### **Item I-3**

PUBLIC HEARING: Consider an ordinance approving amendments to the City of Keller Unified Development Code, adopted by Ordinance No 1746, dated July 7, 2015 by amending Article 3, Definitions; and Article 8. Zoning Districts. Development Standards. Tree Preservation. Section 8.03 Zoning Districts. Town Center. Section 8.06 Service Area Design and Requirements. Section 8.13 Screening Wall Requirements. Section 8.15 Supplementary Regulations. Section 8.18 Illustrations. and Section 8.19 Tree and Natural Feature Preservation. City of Keller. applicant. (UDC-18-0008)

## **Item I-3: Design Standards for Service Areas**

Figure 20 - Pedestrian Access for Typical Waste Container Screening Closure

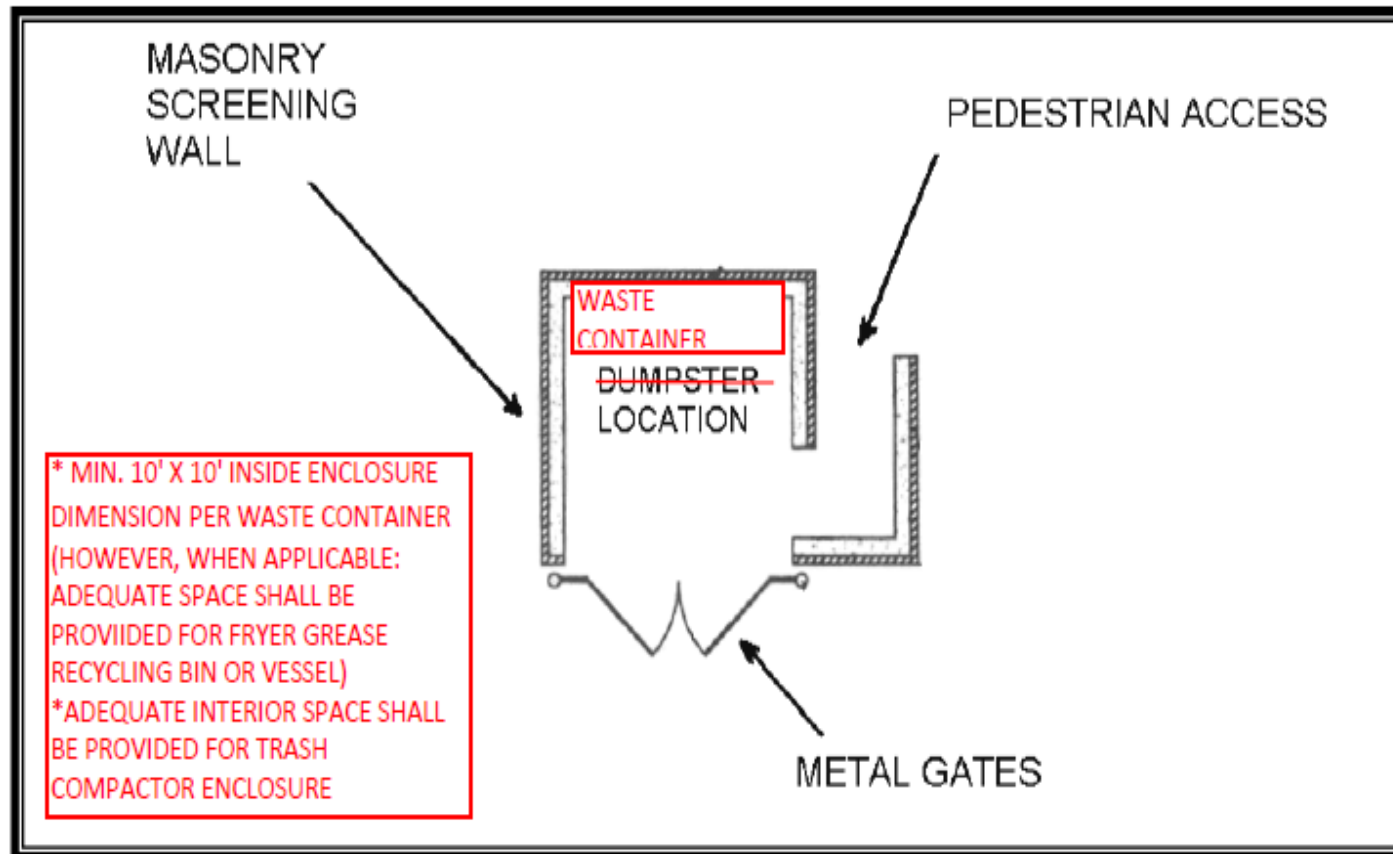
- 2. Service areas and ~~trash receptacles~~ waste containers (including fryer grease recycling bin or vessel when applicable) and trash compactors shall be located at the rear of the property and shall not face a street. The ~~dumpster waste containers and trash compactors~~ shall be screened with a masonry wall compatible in material and color with the primary building. ~~Solid metal frame doors~~ Door frames made of tubular steel shall be utilized for ~~dumpster waste container and trash compactor screening closure wall gate.~~ Door frames and door covering shall be able to support and function for the intended use and shall be approved during site plan approval; however, no wood is permitted. A pedestrian access point shall be provided for access to a ~~dumpster location~~ waste container and trash compactor enclosure to facilitate access without opening the gate (see Section 8.18 – Figure ~~19-20 and 21~~).

**Bottom Line:** *Door frames are to be made of tubular steel and door coverings may be made of any material other than wood.*
